REPORT AMENDED BY STAFF 5-9-89  
**CITY PLANNING COMMISSION**

- APPLICATION:
- A. Negative Declaration
  - B. Special Permit to develop a 162,235± sq. ft. office building with 630 parking spaces in the Heavy Commercial-Review (C-4-R) and Heavy Industrial (M-2) zones
  - C. Plan Review for a 162,235± sq. ft. office building in the C-4-R zone

LOCATION: East side of Main Street, 300± feet north of Arden Way

## Phase I & II

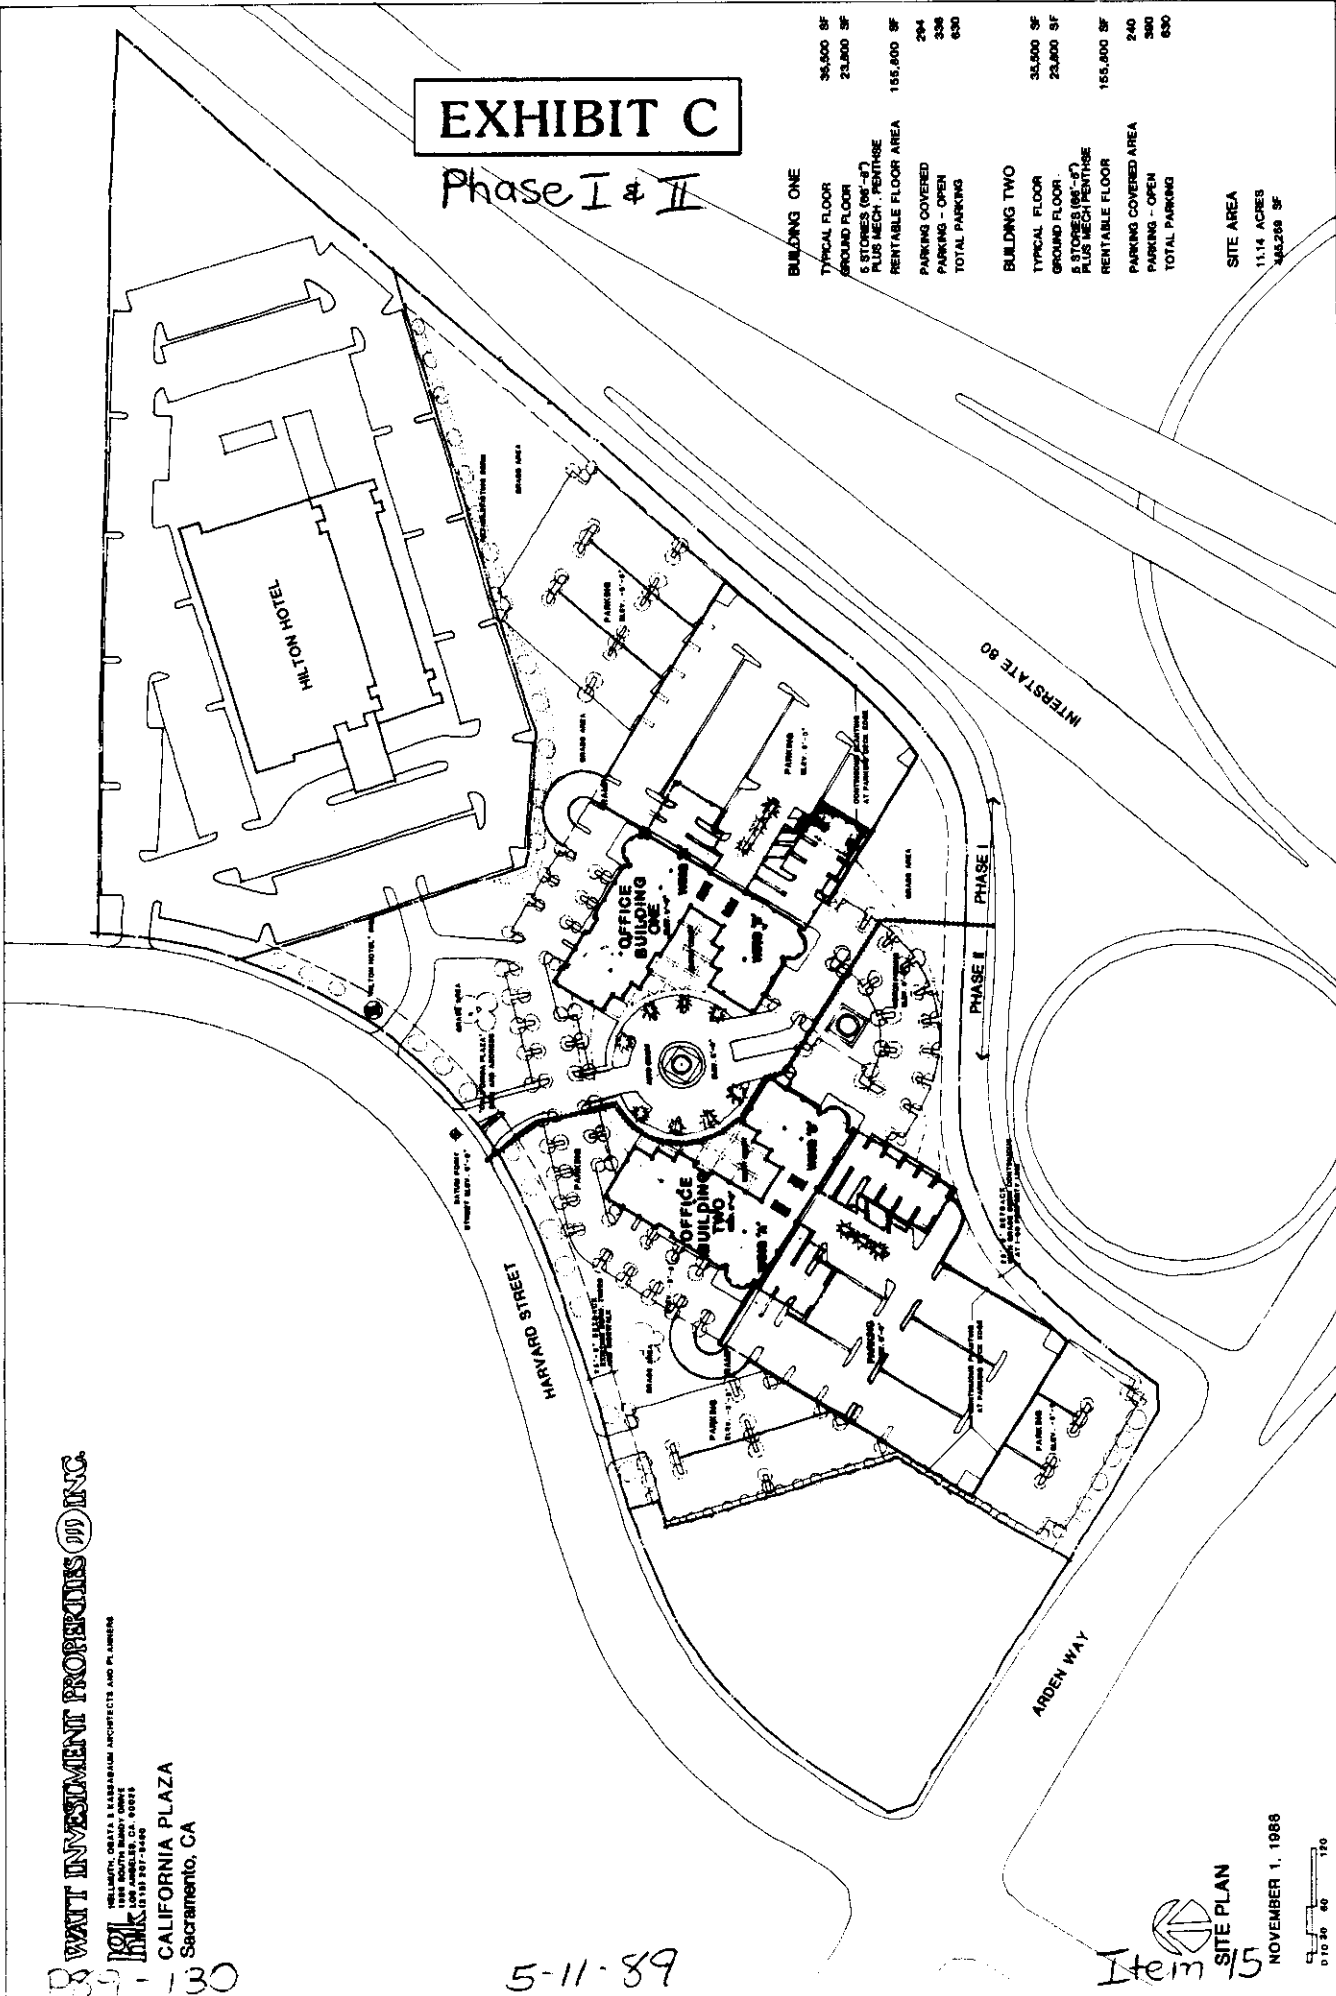
1. All driveways shall be parallel to the street. Entry driveway divider shall be set in 20 feet from property line.
2. Provide plans showing parking ramp elevations and stall specifications.
3. Southern driveway shown for Phase II should be 30 feet in width and align with parking aisle.

# EXHIBIT E

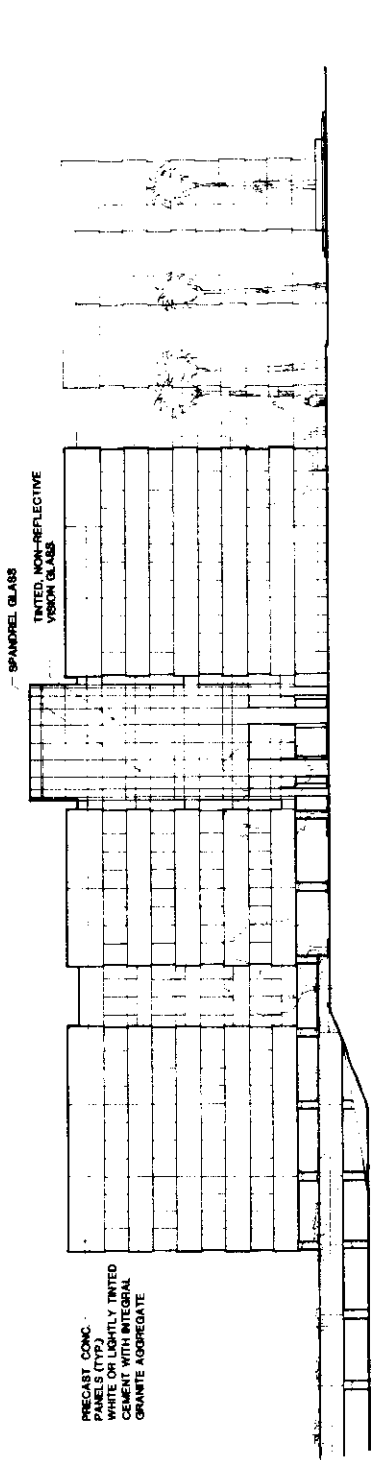
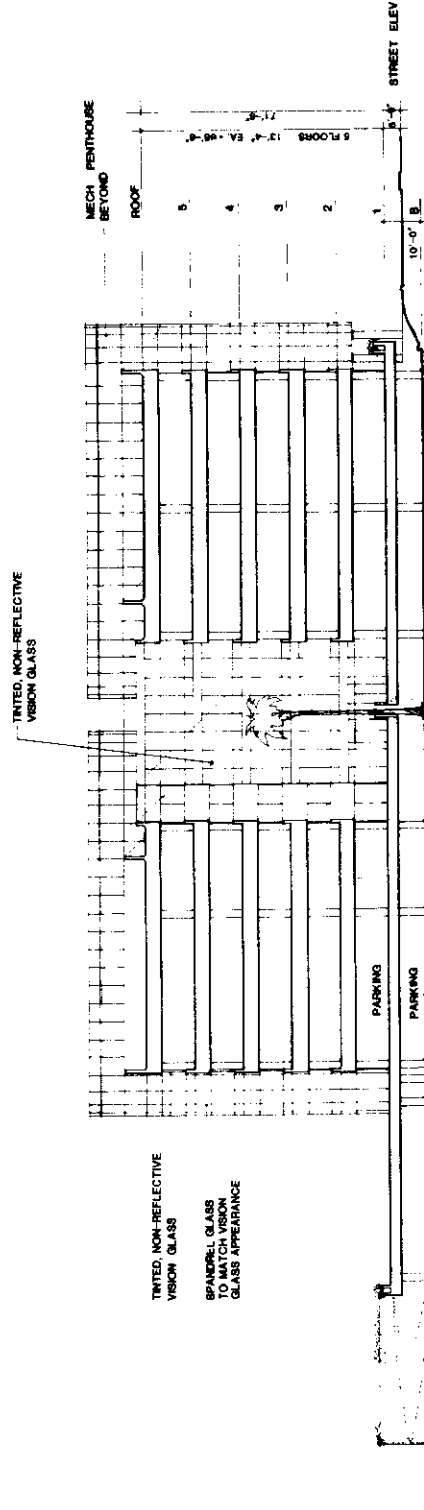
Planning staff finds the proposed building design to be interesting and compatible with the adjacent office buildings and Hilton Hotel. The building height is within the limits of the C-4 and M-2 zones (Maximum height 75 feet to plate line, 90 feet to top of mechanical equipment penthouse) and is similar to the surrounding buildings. The proposed building should have a decorative motif incorporated into the pre-cast concrete panels, such as the use of reveal lines. Planning staff prefers the sand pre-cast concrete and green tinted glass material samples presented by the applicant rather than the white/grey combination as the white building appears too stark. Planning staff recommends that the final architectural detailing for the project be reviewed and approved at staff level prior to issuance of building permits.

## Phase I & II

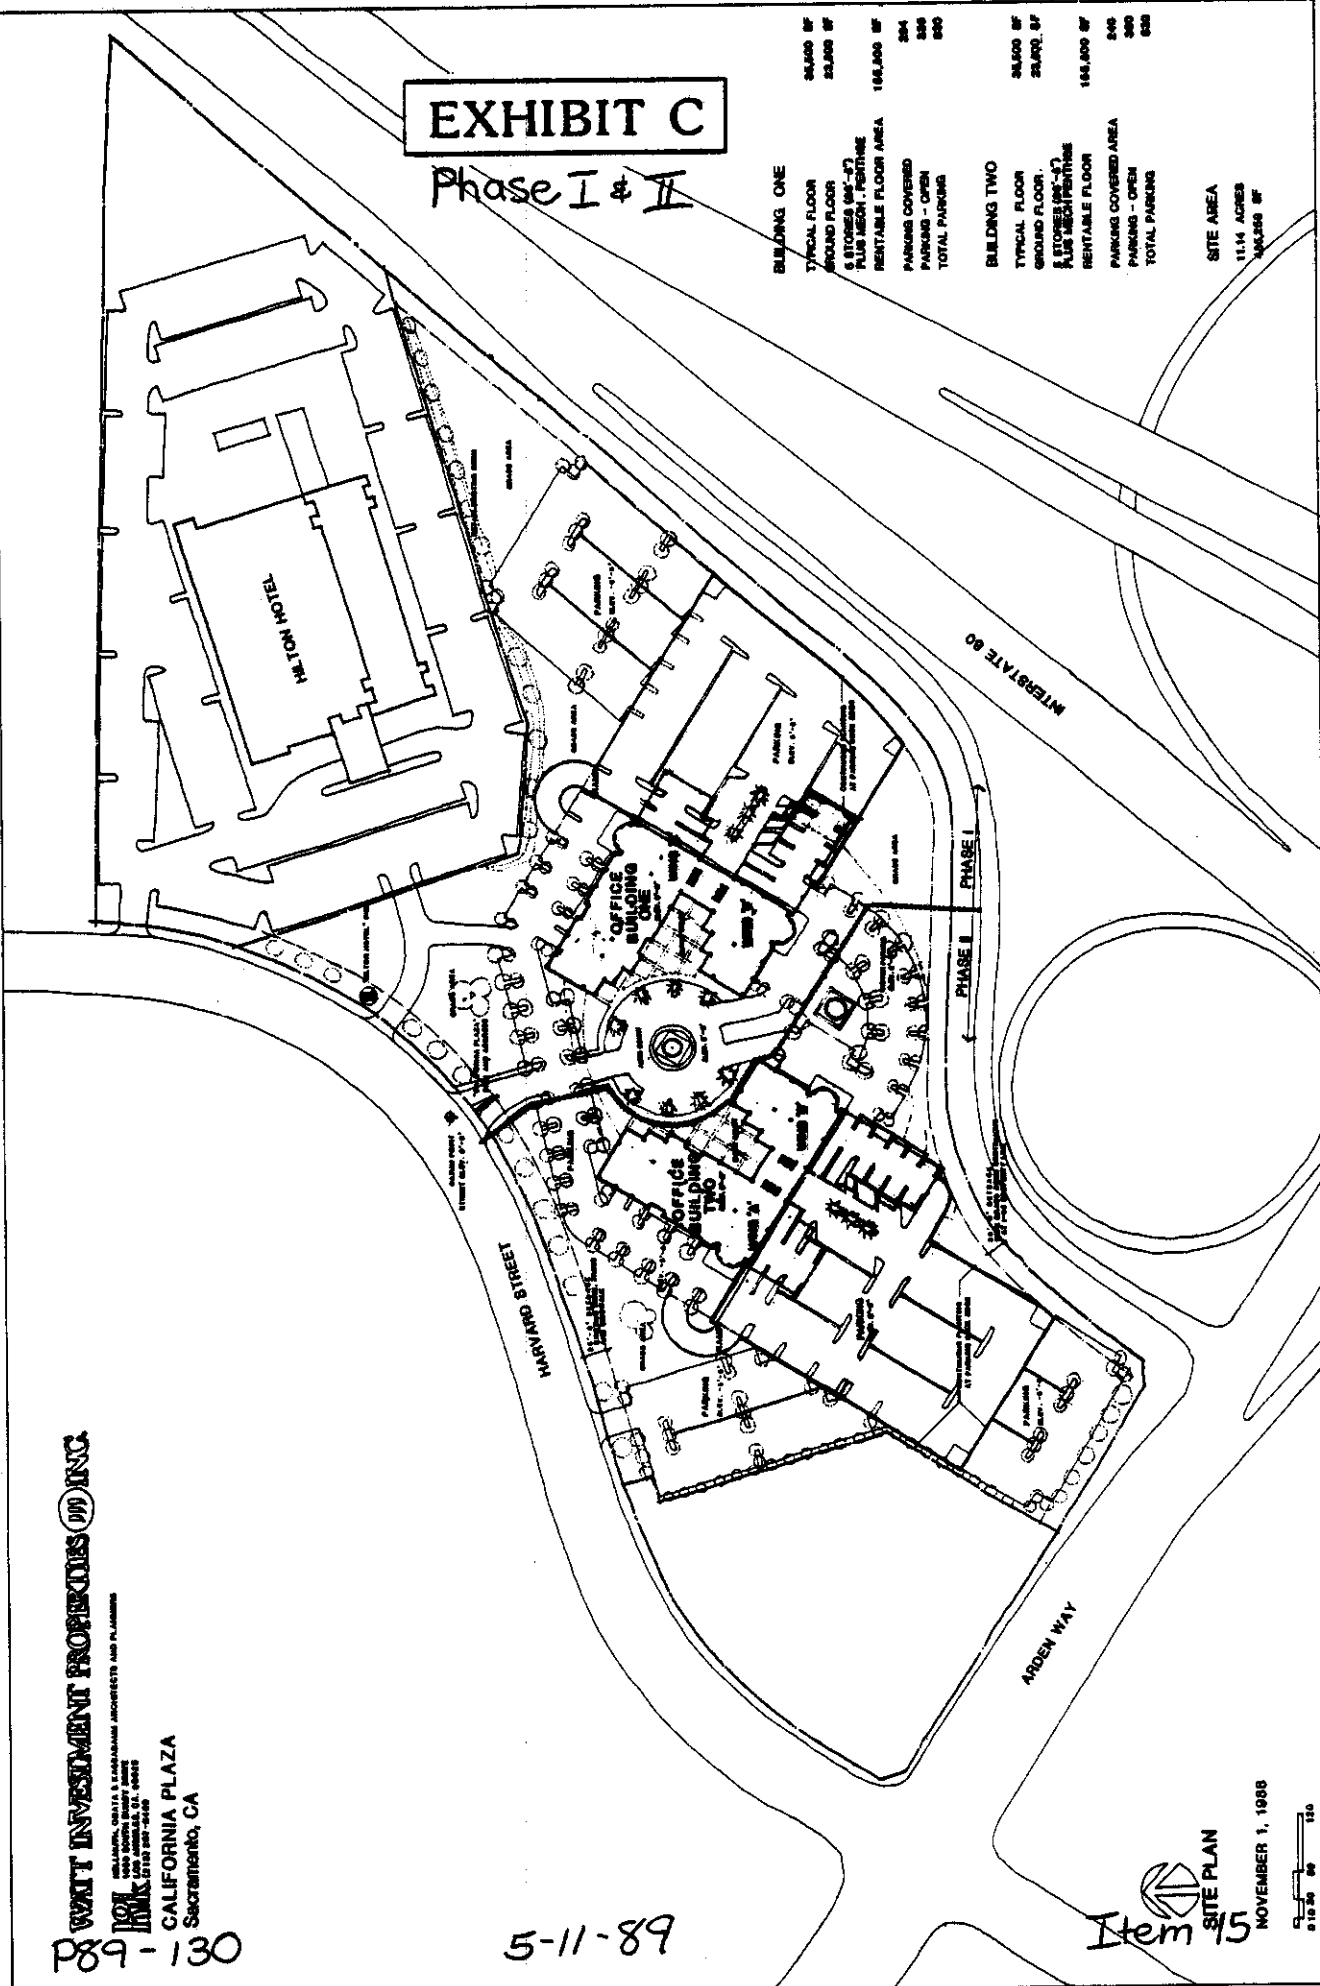
1. All driveways shall be parallel to the street. Entry driveway divider shall be set in 20 feet from property line.
2. Provide plans showing parking ramp elevations and stall specifications.
3. Southern driveway shown for Phase II should be 30 feet in width and align with parking aisle.

# EXHIBIT E

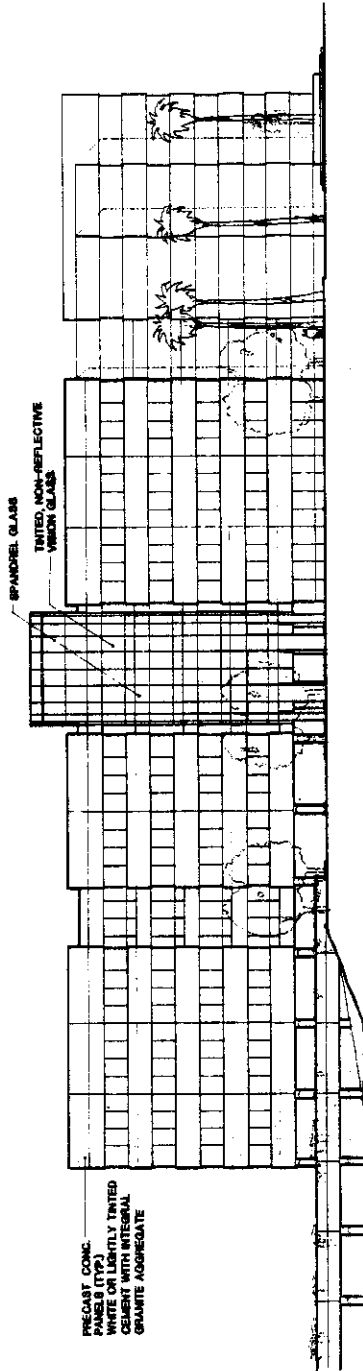
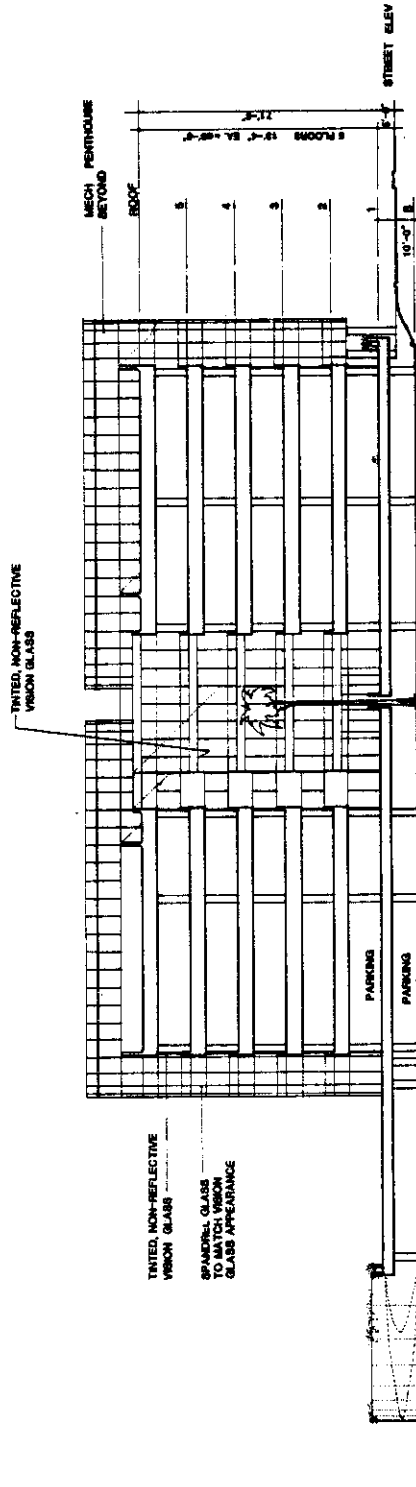
Planning staff finds the proposed building design to be interesting and compatible with the adjacent office buildings and Hilton Hotel. The building height is within the limits of the C-4 and M-2 zones (Maximum height 75 feet to plate line, 90 feet to top of mechanical equipment penthouse) and is similar to the surrounding buildings. The proposed building should have a decorative motif incorporated into the pre-cast concrete panels, such as the use of reveal lines. Planning staff prefers the sand pre-cast concrete and green tinted glass material samples presented by the applicant rather than the white/grey combination as the white building appears too stark. Planning staff recommends that the final architectural detailing for the project be reviewed and approved at staff level prior to issuance of building permits.
